56. Introduction to Ethernet for subscriber access networks

56.1 Overview

Modify a new Figure 56-5a after existing Figure 56-5:

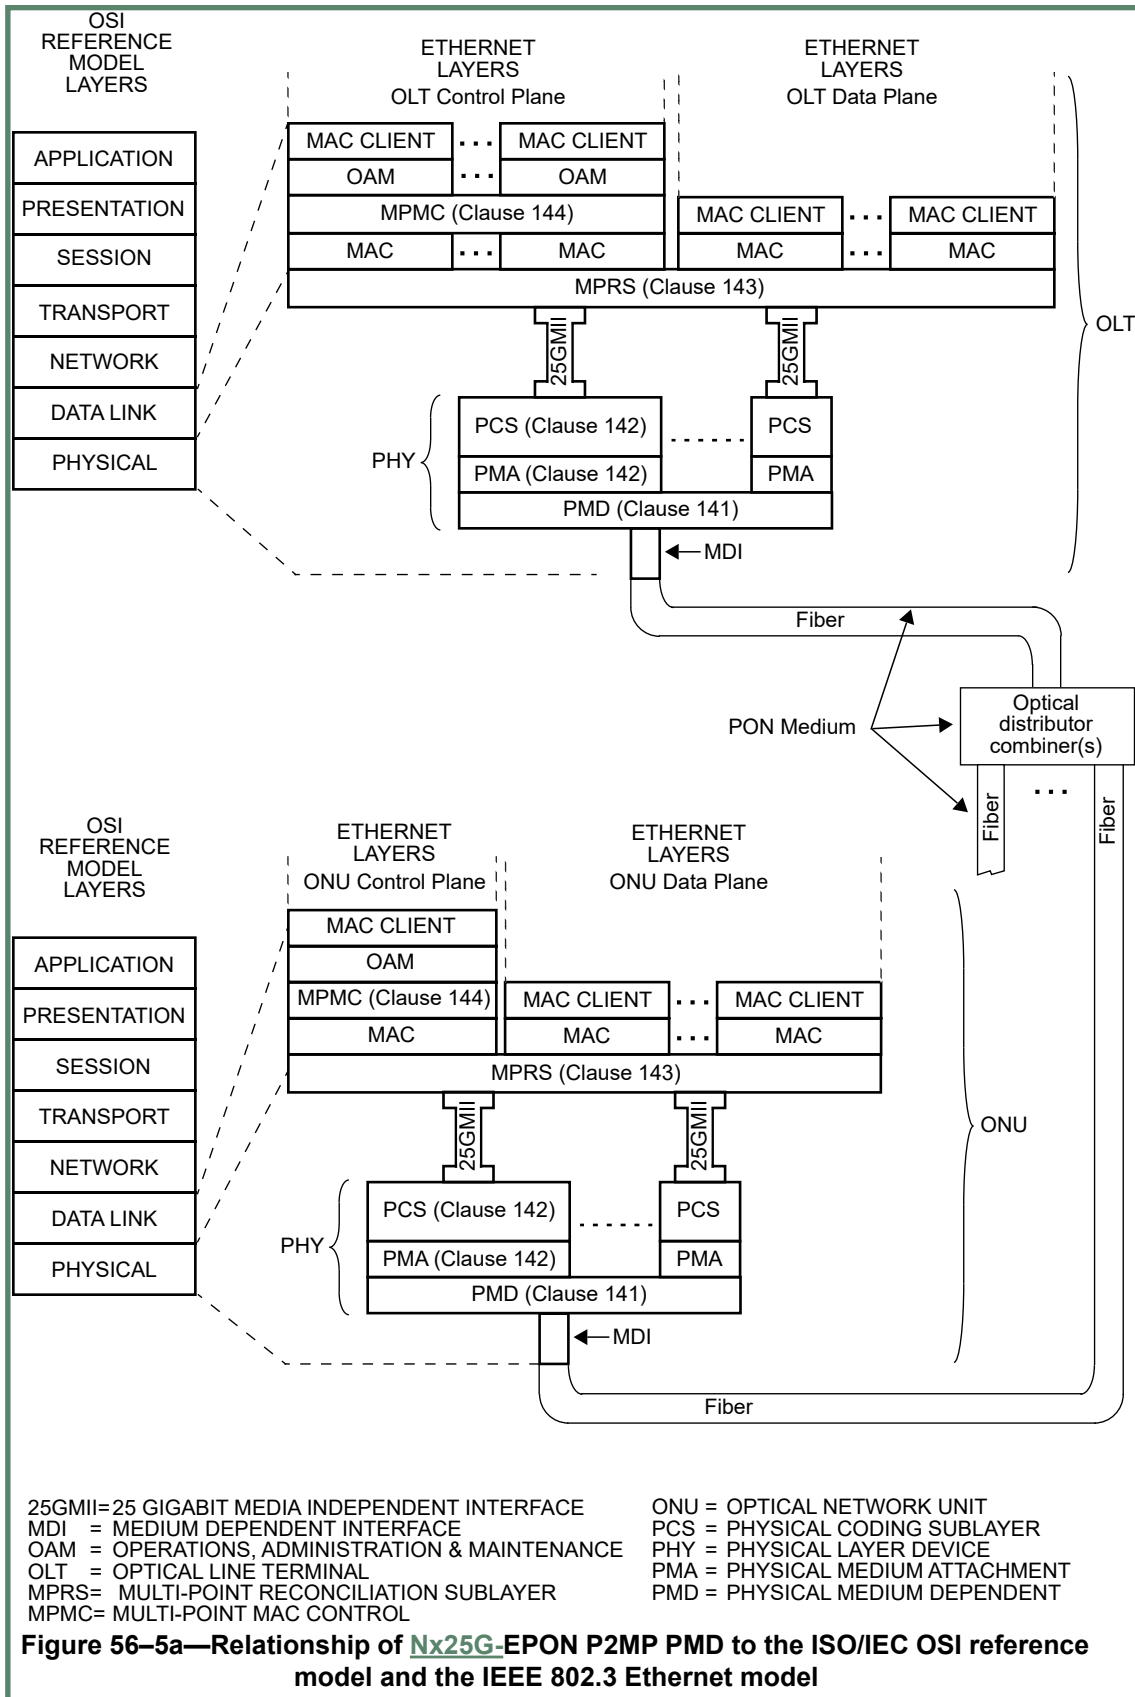
In addition, a mechanism for network Operations, Administration, and Maintenance (OAM) is included to facilitate network operation and troubleshooting. 100BASE-LX10 extends the reach of 100BASE-X to achieve 10 km over conventional single-mode two-fiber cabling. The relationships between these EFM elements and the ISO/IEC Open System Interconnection (OSI) reference model are shown in Figure 56–1 for point-to-point topologies, Figure 56–2 for 1G-EPON topologies, Figure 56–3 for 10/10G-EPON topologies, Figure 56–4 for 10/1G-EPON topologies, ~~and~~ Figure 56–5 for EPoC topologies, ~~and~~ Figure 56–5 for Nx25G-EPON topologies.
